REPORT PD-2015-017

SUBJECT: Second Public Meeting - Rezoning Application File D14/PER – Persian Investments Ltd. - Part Lot 16, Concession 7, municipally known as 424 Maltby Road

**ZONING BY-LAW AMENDMENT D14/PER
PERSIAN INVESTMENTS
424 MALTBY ROAD
TOWNSHIP OF PUSLINCH**

COMPREHENSIVE RESPONSES TO AGENCY COMMENTS RECEIVED

FIGURE 1. OUTER NEW LIMIT OF WOODLAND, 424 MALTBY ROAD.

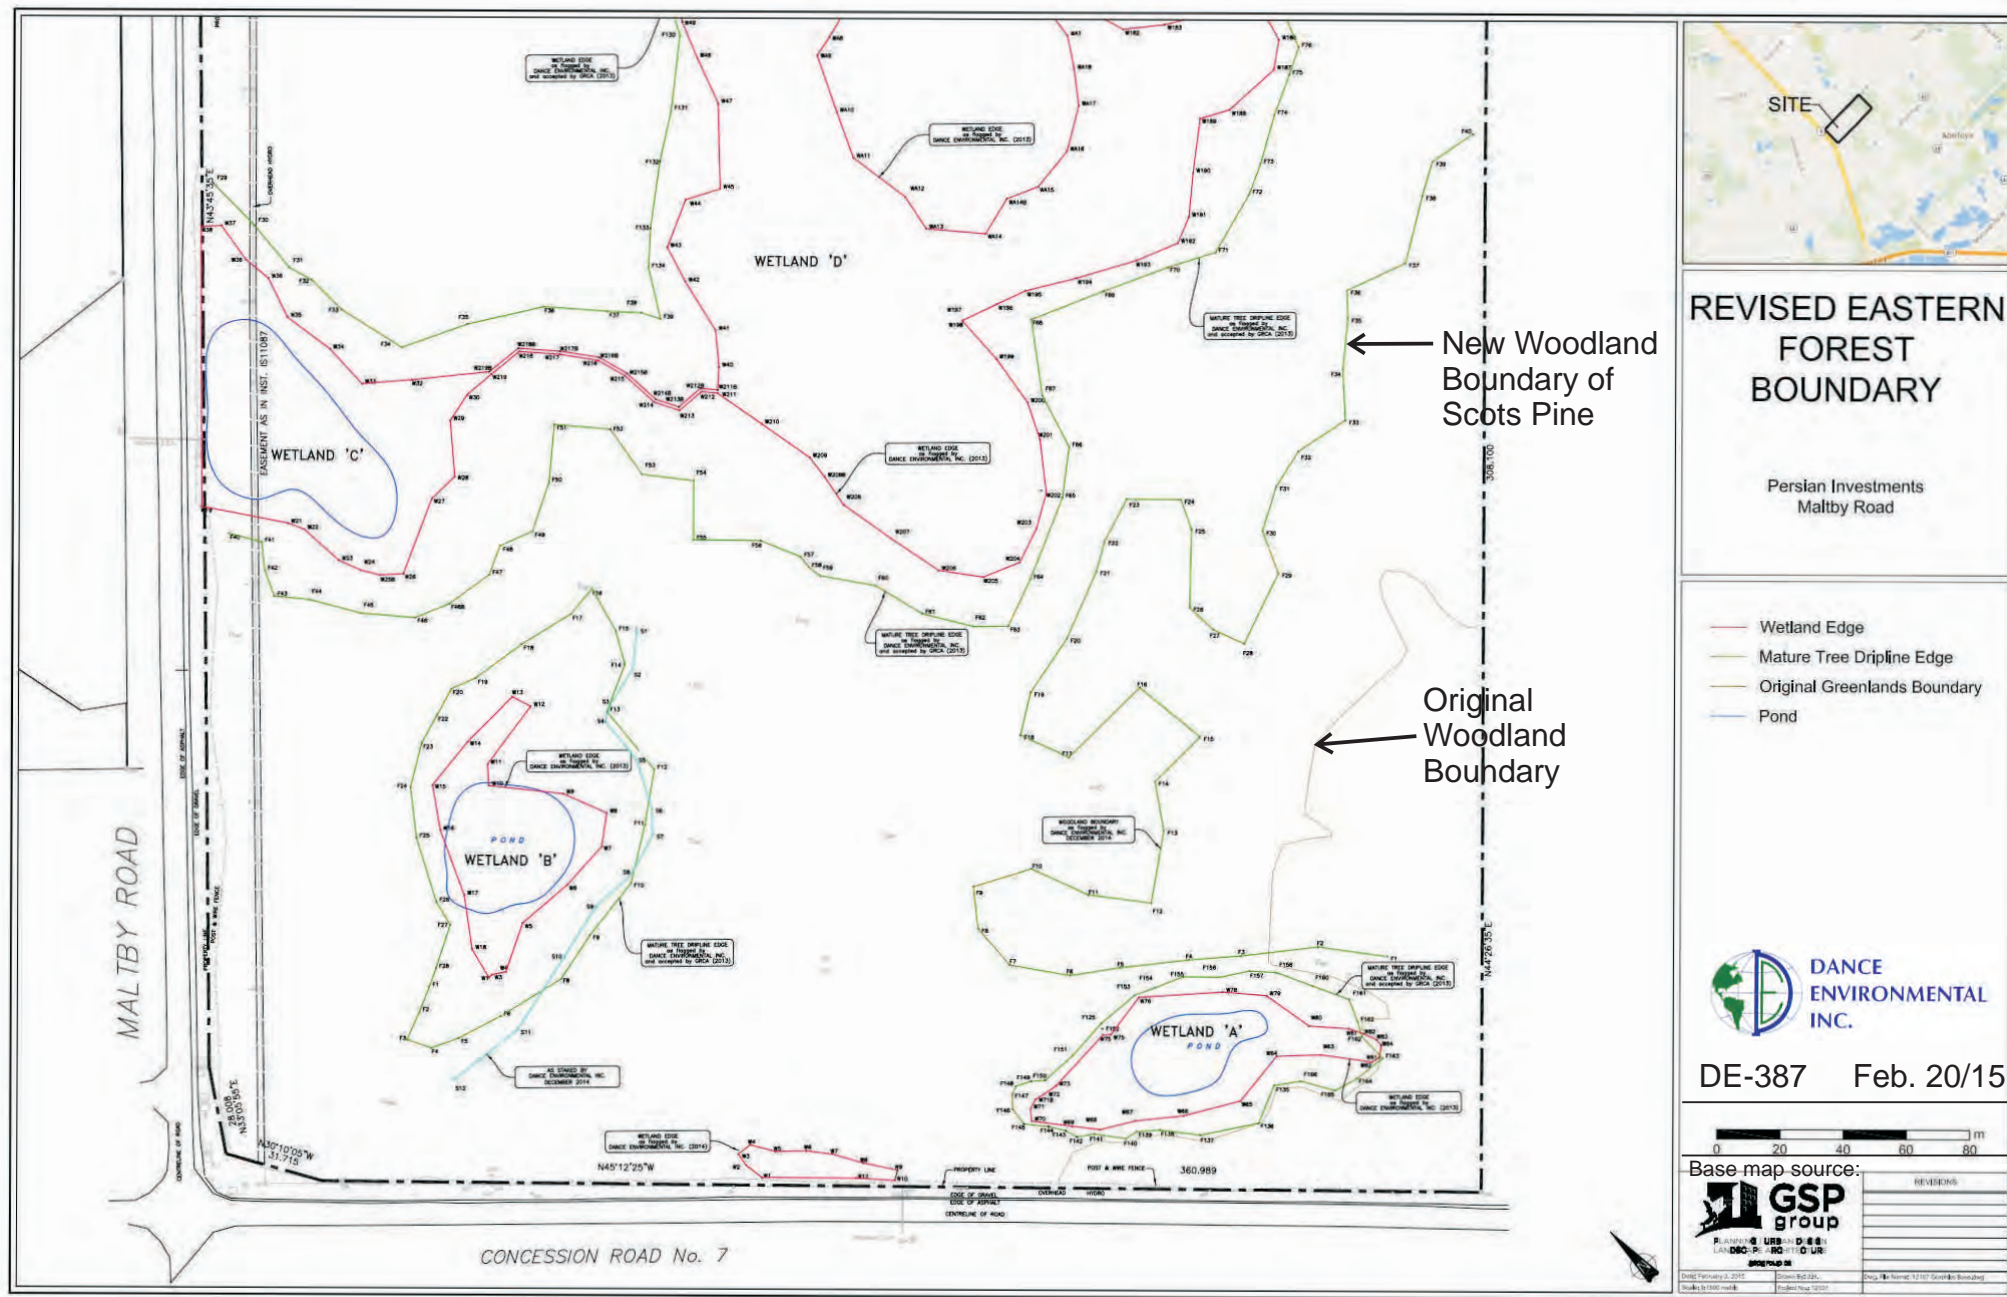
<p>4. Staff agree that the conifer plantation associated with the woodland should be regarded as significant and zoned (protected) as Greenland. Staff suggest that the boundary of this conifer community is somewhat vague and would recommend the County confirm the woodland boundary.</p>	<p>is provided below. There has been no proposal by the proponent to reduce the 30m buffer from Wetland A that was described in the April 2014 E.I.S.</p> <p>Art Timmerman – Nov. 26, 2014 Email: <i>Ken: After reviewing your report SCOPED EIS 424 Maltby Road, Wellington County, Township of Puslinch (April 16, 2014) I have added the previously un-evaluated wetland polygon A to the Mill Creek Puslinch wetland complex. This wetland polygon is centred at approximately UTM 17 565846E 4813569N.</i></p> <p>As described in the response to the GWS comments the woodland boundary has been confirmed, surveyed and plotted.</p>

1. As previously indicated, I am satisfied with the revised mapping of the woodland boundary for vegetation community FOCM6-3, an immature Scotch pine plantation. This forest community extends off-site to the east and south. Based on GRCA air photography it encompasses approximately 11.6 hectares and is also connected to other coniferous and deciduous forest stands which collectively appear to comprise over 50 ha of woodland. Wellington's Country 2015 Official Plan states that in the Rural System woodlands over 4 hectares and plantations over 10 hectares are considered significant and are included in the Greenlands system. Although Scotch pine is a non-native, invasive species it is nonetheless considered a protected species under the County's Tree By-law. Consequently, the entire revised area of FOCM6-3 on the subject property represents Greenlands, not just a portion of it as shown in Dance's Figure 3, the Conceptual Site Plan, or the GSP Demonstration Plan. The Greenlands designation does not, however, preclude a potential development intrusion into the woodland area provided there are no negative impacts on significant features and functions. The proponent must therefore demonstrate that the proposed loss of x acres of Scotch Pine plantation will not compromise the integrity of the residual Greenlands area. Appropriate enhancement of the residual woodland would be considered ecologically desirable. In any event, an acceptable Greenland boundary must now be established to facilitate the amendments required to the Zoning By-law in order for any industrial development to proceed. This

**Figure 3. Conceptual Site Plan,
424 Maltby Road.**

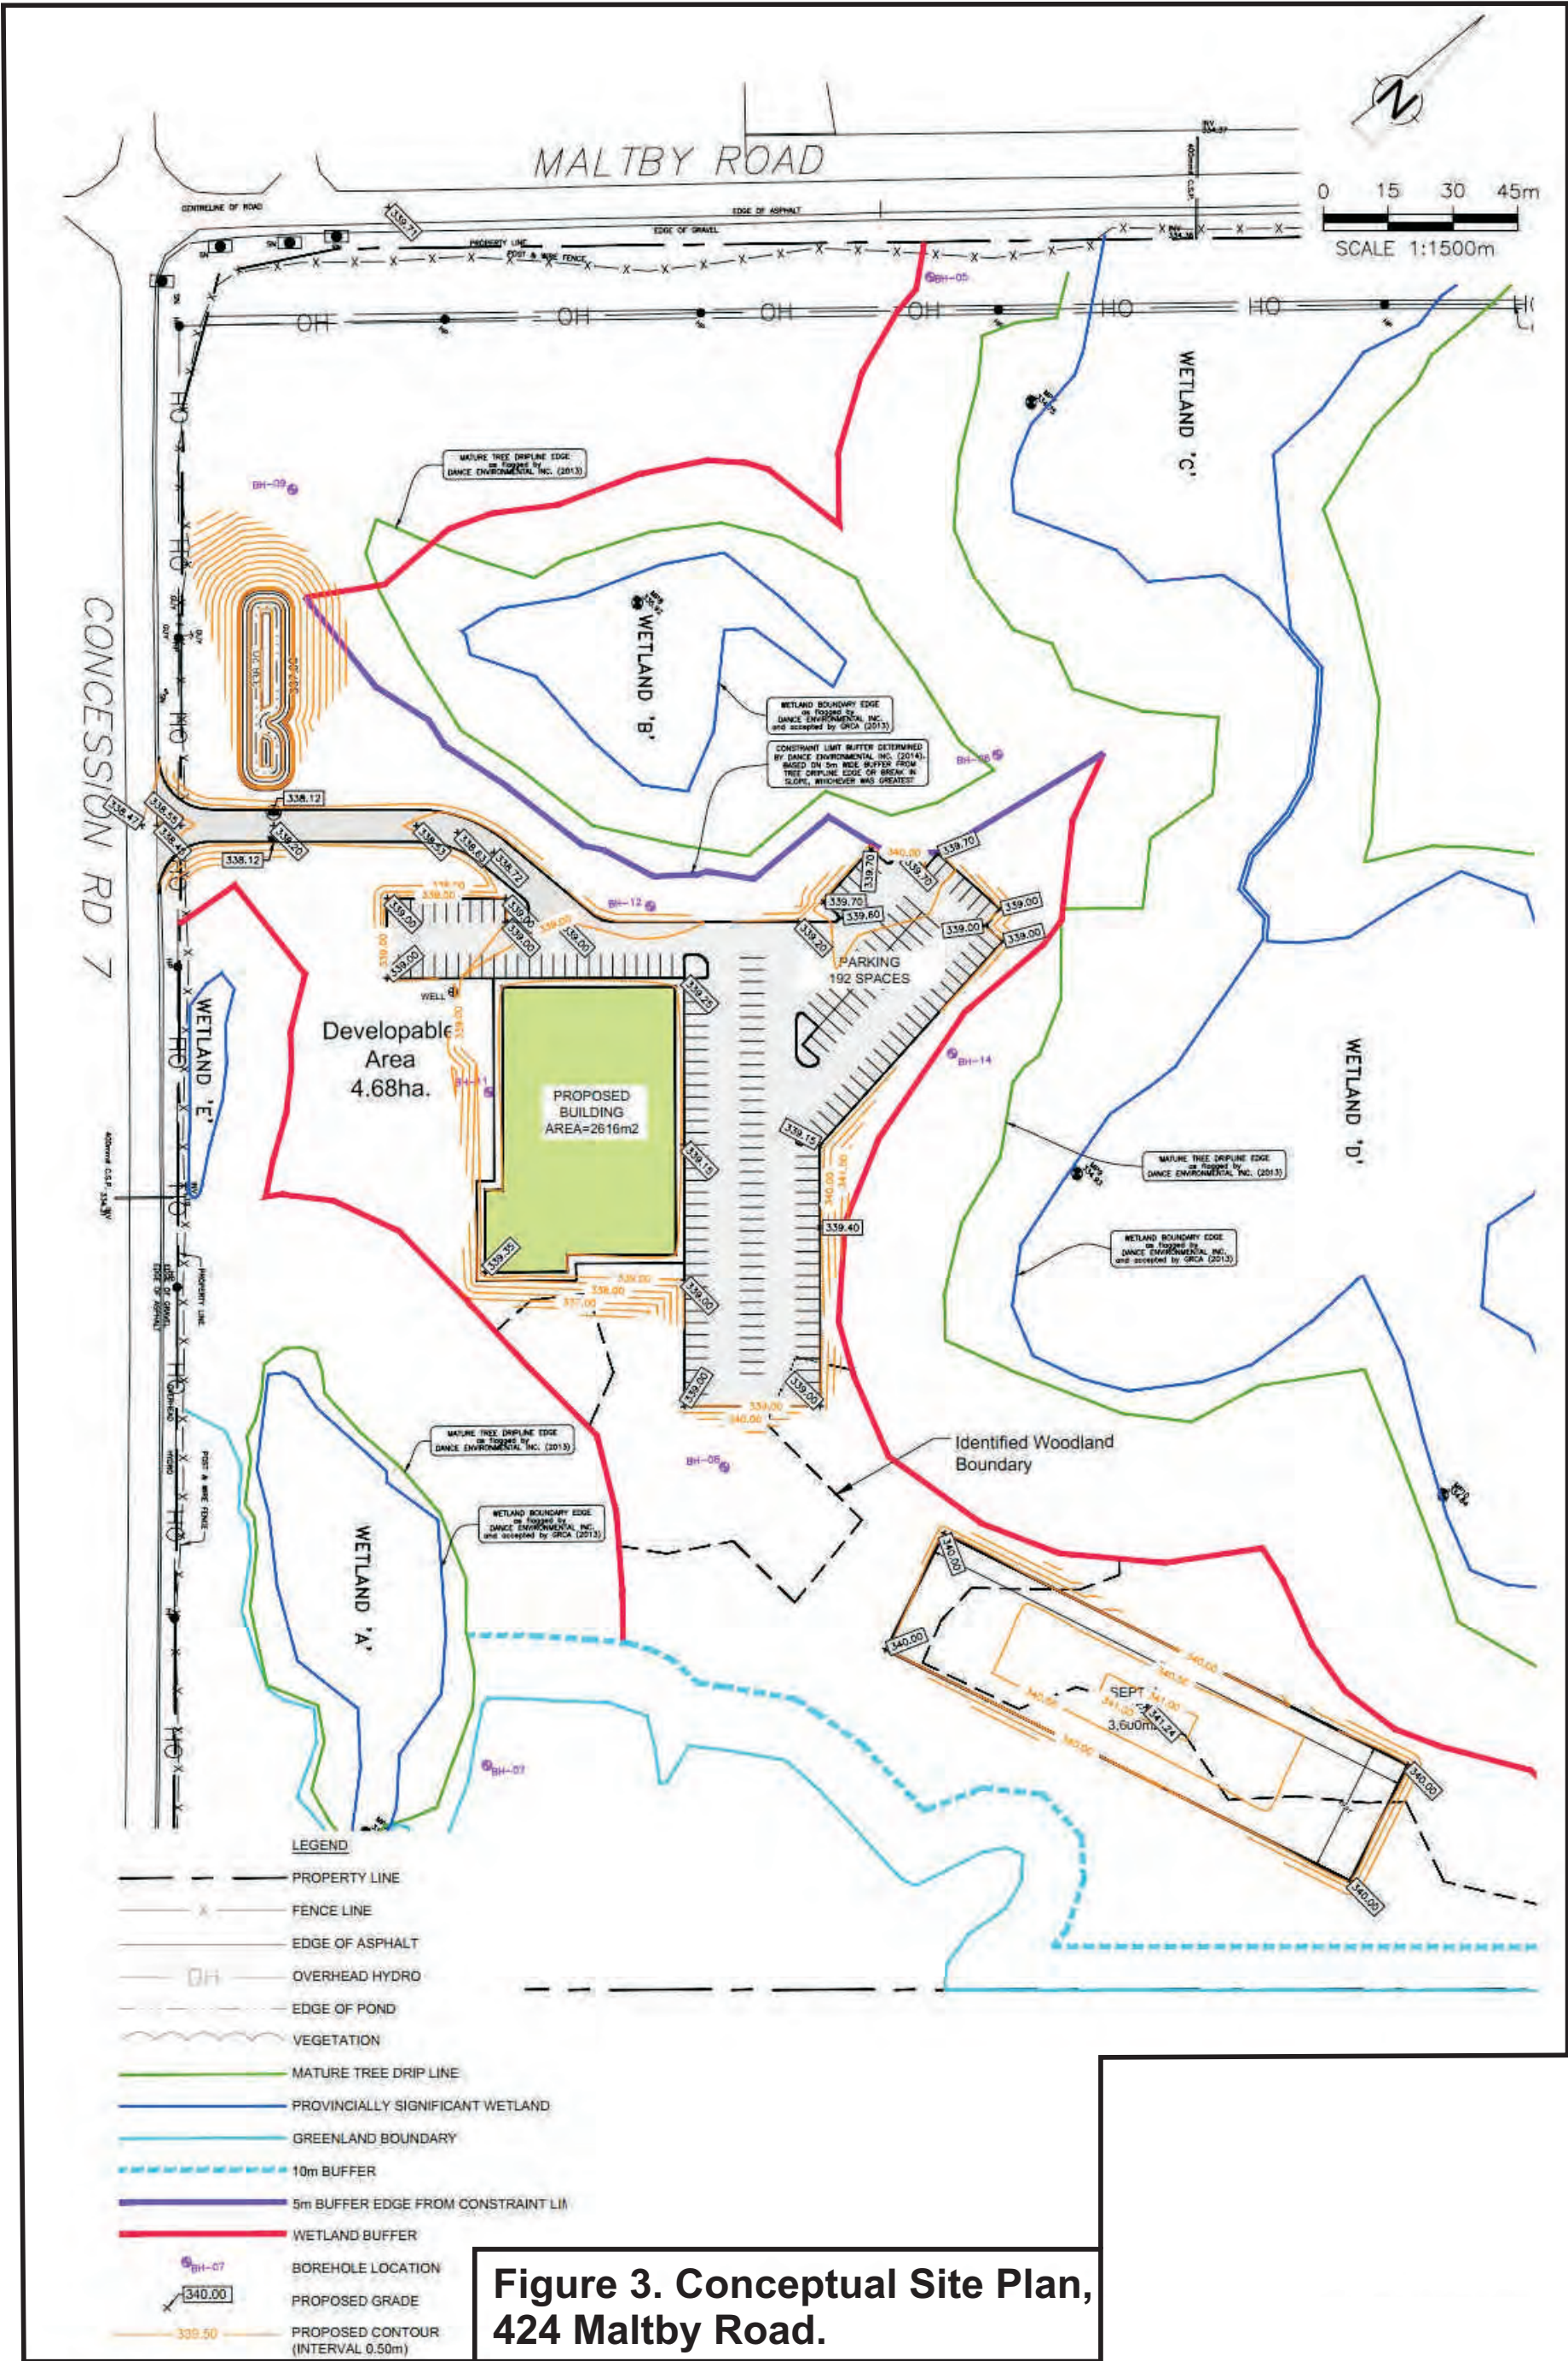
2. The size of the septic area shown on the Demonstration Plan seems very large in relation to the size of the building. Since it is partially located within the revised Greenland area some justification should be provided to support the proposed location, size and shape of this structure.

FIGURE 4. CONSTRAINT LINE & SETBACK FROM WETLAND B.

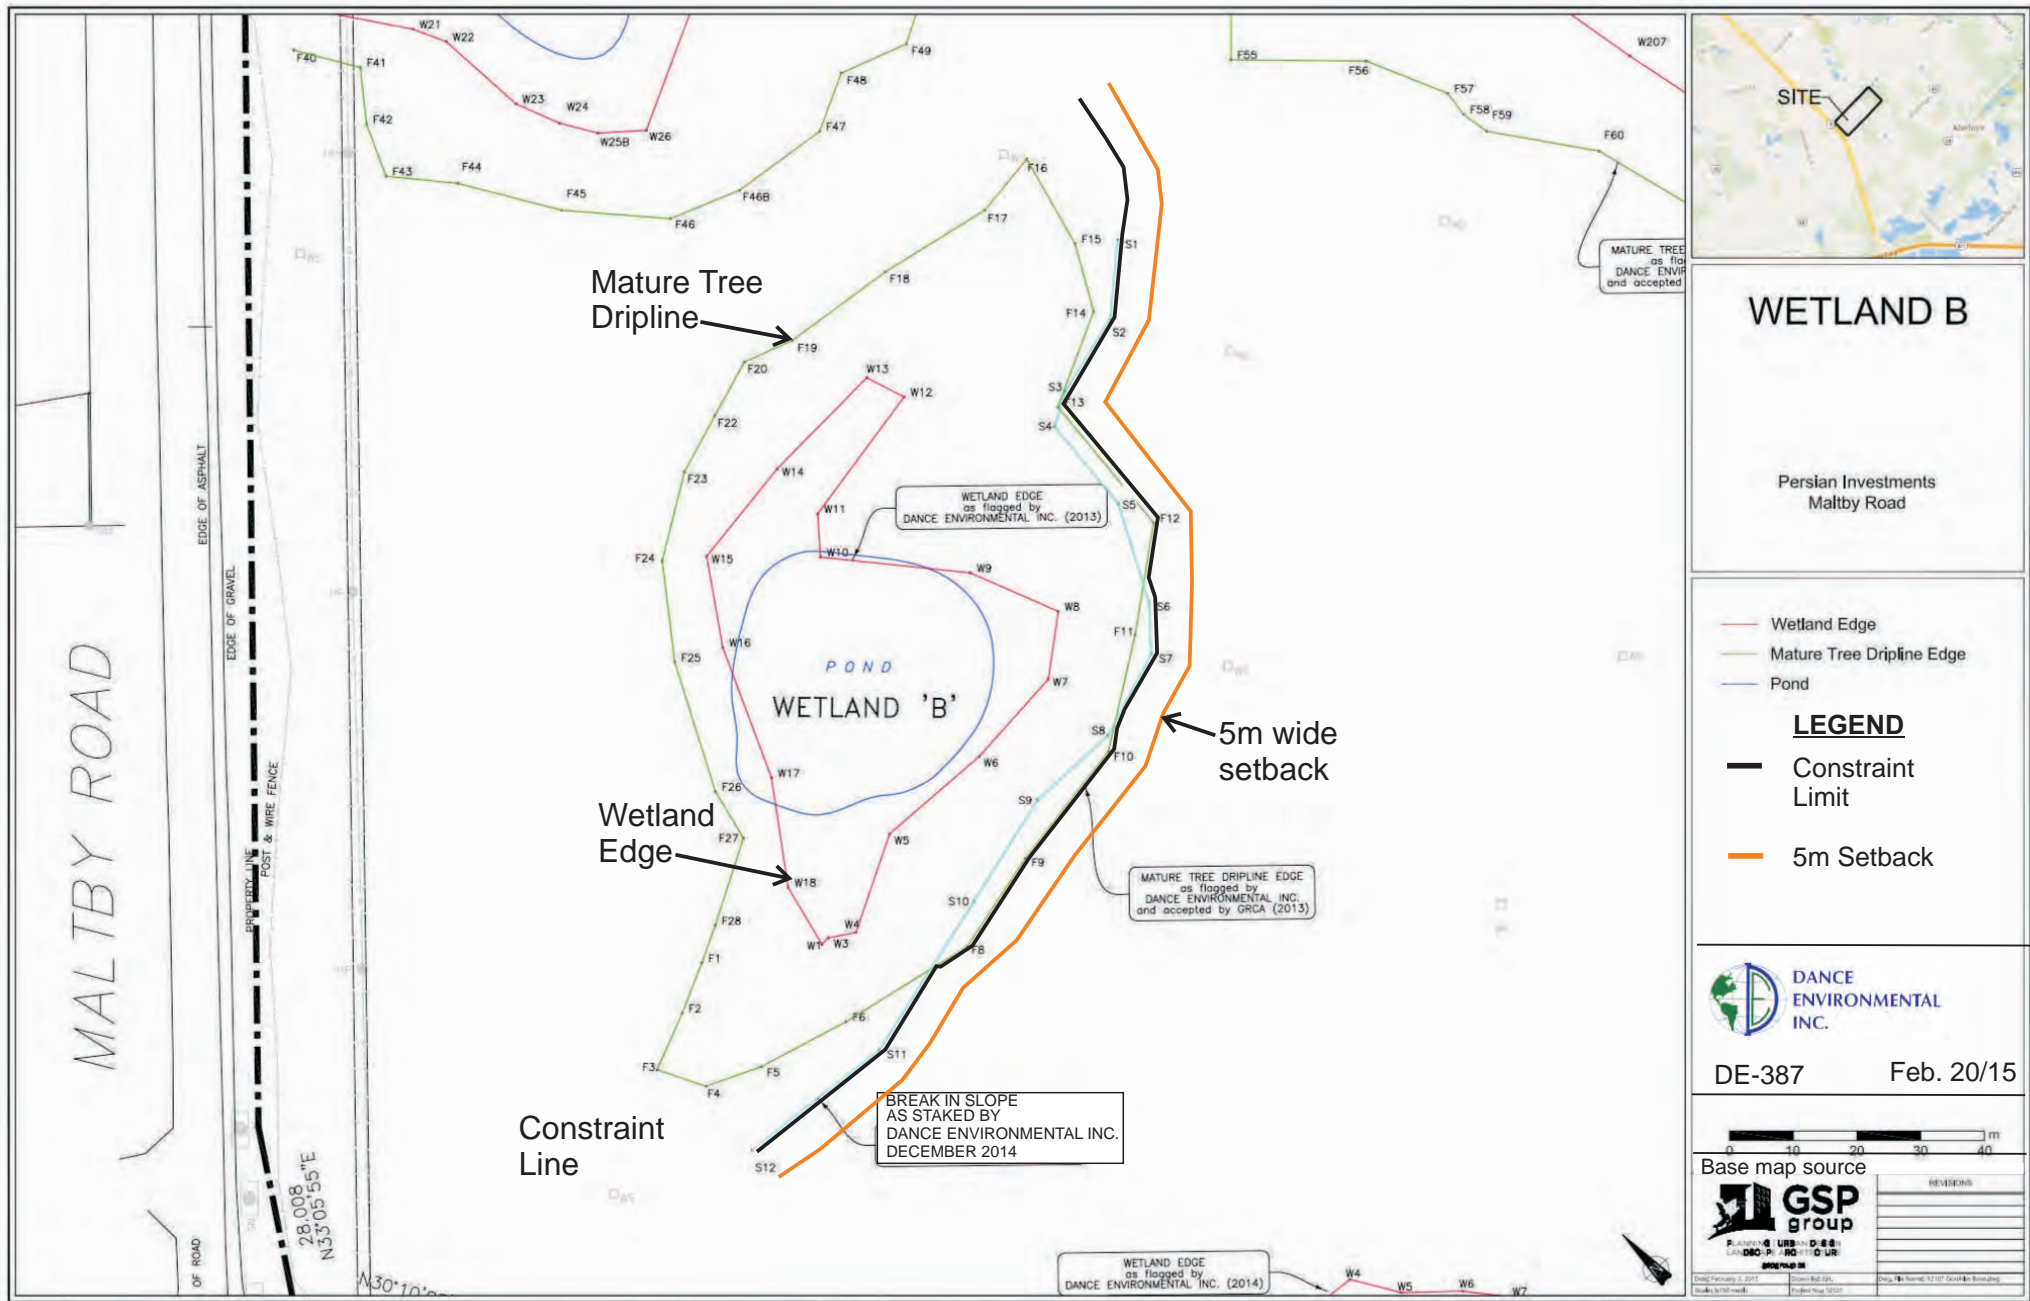
3. On page 57 and 58 there is a discussion about the use of a 15 to 20 m buffer around wetland B. It is presented in a somewhat confusing manner. Since this wetland feature is of low quality I suggest this issue can be simplified by establishing a 1 m setback from the dripline of existing mature trees. This would result in an easily recognized buffer that varies from about 10 to 30 m in width.	GWS has suggested an approach for establishing the buffer width adjacent to Wetland B. The GRCA has suggested a different approach for determining an appropriate buffer width. It is expected that GWS will find the approach that we used to respond to the GRCA comments acceptable. See a later section of this letter for the response to GRCA.	Setback is now proposed as a 5m setback from the outer limit of the mature tree dripline of from the break in slope (as suggested by the GRCA), whichever is farther upslope from the southern margin of Wetland B. See Figure 4. Setbacks to be respected during Site Plan Approval.

<p>consists of a simple cattail fringe. The wetland is 400m² ± in size. Since this wetland is not known to contain any significant features, a 15m wide buffer from the wetland margin is recommended. The entrance driveway, parking and building envelopes are all more than 30m from this wetland.</p> <p>The SWM facility proposed to be placed to the north of this wetland is 15m± away from the wetland margin.</p> <p>It is our opinion that the updated Conceptual Site Plan (see Figure 3 attached) would not impact this small wetland feature. Sediment control fencing would be used to prevent any sediment from washing into this wetland during construction.</p>	
<p>2. With respect to 'Wetland B', the proposed 15 m buffer illustrated in Figure 6 is not consistent with recommendation #12 in Section 10.0, which states "A 20 m wide buffer, undisturbed by development, is recommended around 'Wetland B' since there are limited ecological features and functions present." Staff are not in agreement with this assessment. Full choruses of spring peeper, wood frog, and gray tree frog were documented in this pond. Therefore, this wetland may meet the criteria for designation as significant wildlife habitat (i.e. specialized amphibian breeding habitat) in accordance with the OMNR's EcoRegional Criteria (Schedule 6E). Consequently the GRCA believes there is insufficient justification in the EIS to support a 15 metre setback.</p>	<p>During the site visit with GRCA staff it was discussed that Table 7 in the E.I.S. confirms that there were no frog choruses associated with Wetland B. This wetland has very little herbaceous vegetation present, it is primarily a depression surrounded by Silver Maple trees.</p> <p>During the site visit Tony Zammit of the GRCA asked that along the southern edge of Wetland B (the side where development is proposed) the break in slope which defines the area of surface water flow to Wetland B be staked. Figure 4 (attached) shows the break in slope in pale blue.</p>

4. With respect to the protection of wetland B, I have no concern with the proposed 5 m setback from the break in slope or the dripline of mature trees which surround this wetland pocket.
